N4901B-01A-S

S E R V I C E N O T E

N4901B - Serial Bert 13.5 Gb/s

POSSIBLE FIRE HAZARD

Polypropylene Molding**Start of Fire****Graphics Card**

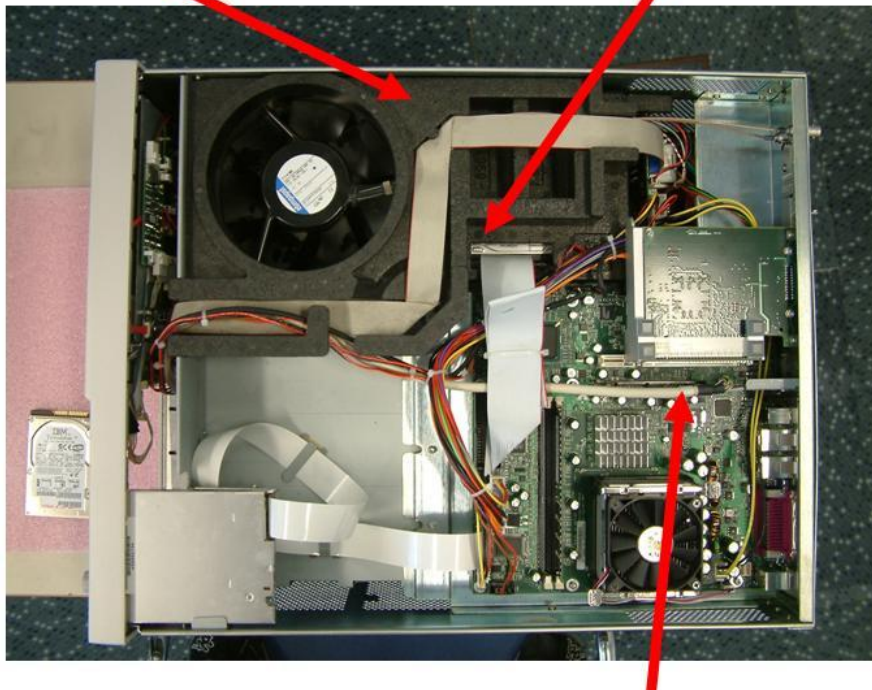
A surface-mount ceramic capacitor suffered physical stress during the manufacturing process, leading the capacitor to crack. During operation this crack placed stress on the internal structure of the capacitor, and caused the plates to short together. (The plates are separated by very little space, made up of very thin insulators.) This caused the capacitor to have very low residual impedance, resulting in a very high current conducted through the capacitor and the 12V path on the motherboard for some period of time. The low impedance didn't lead to a current high enough for blowing the fuse. Therefore the higher current was available long enough to create a very high temperature ($T > 300^{\circ}\text{C}$). The high temperature ignited the polyurethane molding used to conduct the airflow for cooling through the instrument.

The following photo illustrates the layout of the instrument. It shows the polypropylene molding, the graphics card and the starting point of the fire.

The countermeasure for this issue is to exchange the graphics cards. The new graphics cards are produced with an improved manufacturing process eliminating the risk of micro cracks. They either have an additional fusing to protect the 12V path or they have eliminated the 12V path altogether. The graphics card can be exchanged by Agilent authorized personnel only.

Motherboard still considered being good – no exchange required:

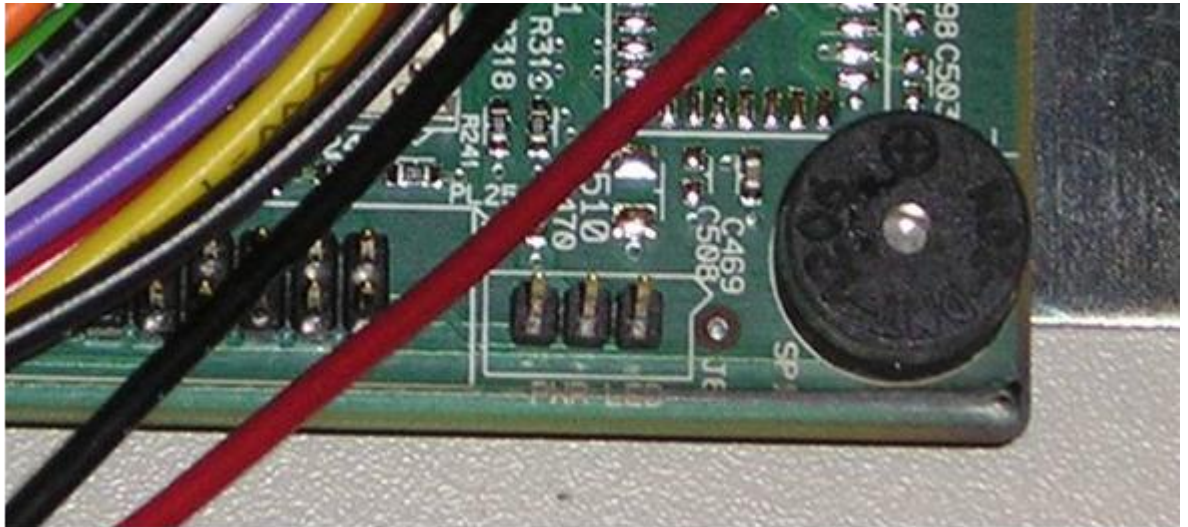
3. Important: Check potential motherboard discoloring

There might be discoloring on the PC motherboard in the shown corner (brown color). This can be ignored. The function or the quality of the motherboard is not affected by this.

Motherboard considered being bad – please exchange:

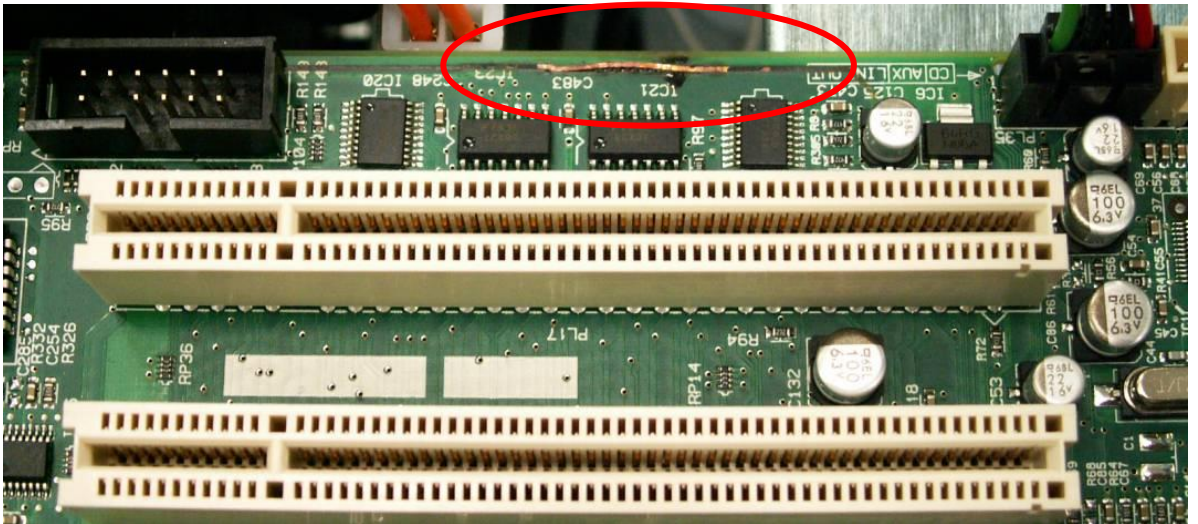
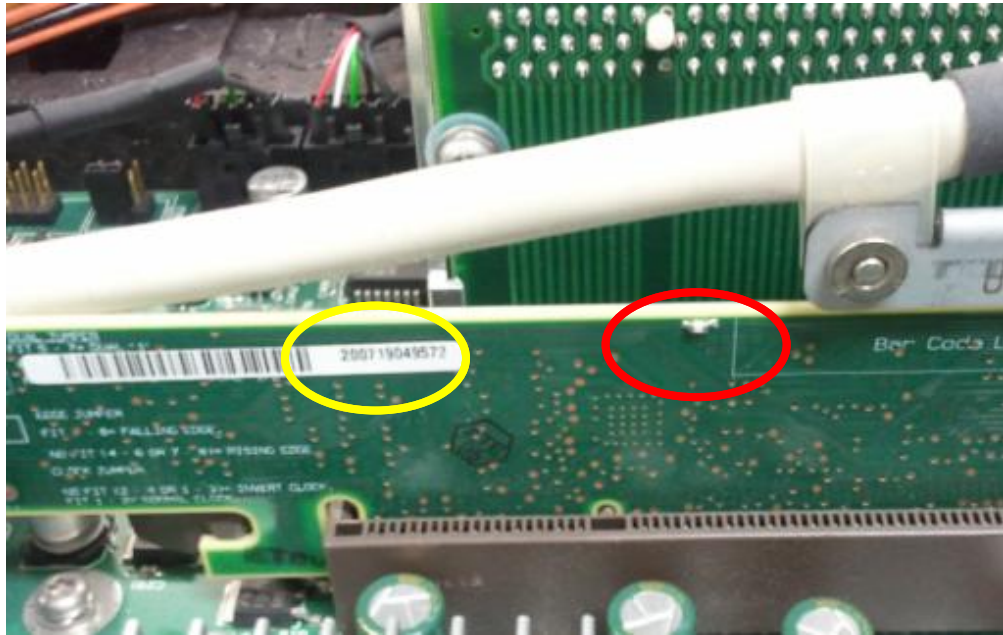
In very exceptional cases if you see traces of smoke or fire, the motherboard needs to be exchanged. In these cases typically the integrated display of the instrument would not work anymore. The exchange of the motherboards can only be done in the Service Center - onsite repair is not possible.

- Sample #2 (Revision NM2502):

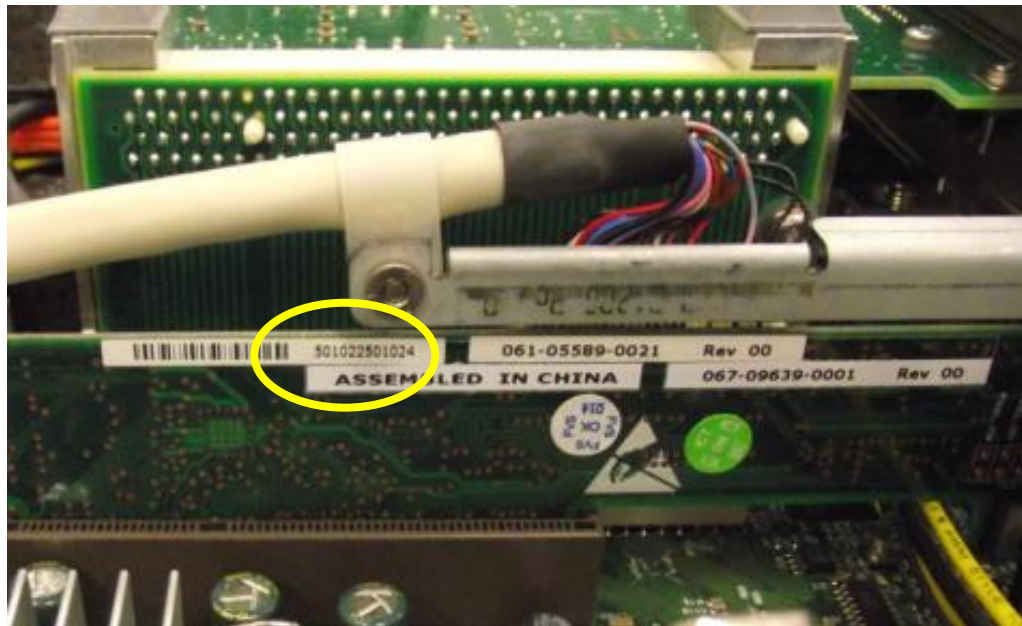
The board has a fuse on top (red circle) and a serial number (yellow circle) starting with 200... In the case above it is 200719049572)

The board has a serial number (yellow circle) **NOT** starting with 200... In the case above it is: 501022501024.

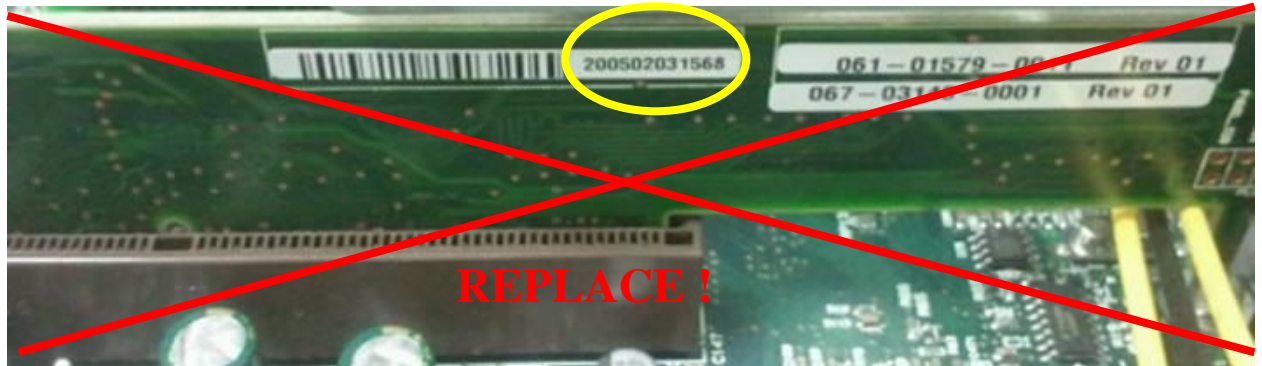
If the graphic board

shows a serial number starting with 200... AND no fuse is visible

it is potentially **hazardous** and the **unit must be set out of operation** until the graphic board is replaced (part number: N4901-66577 or N4901-69577). The graphic board can be exchanged without impacting the instrument's performance.
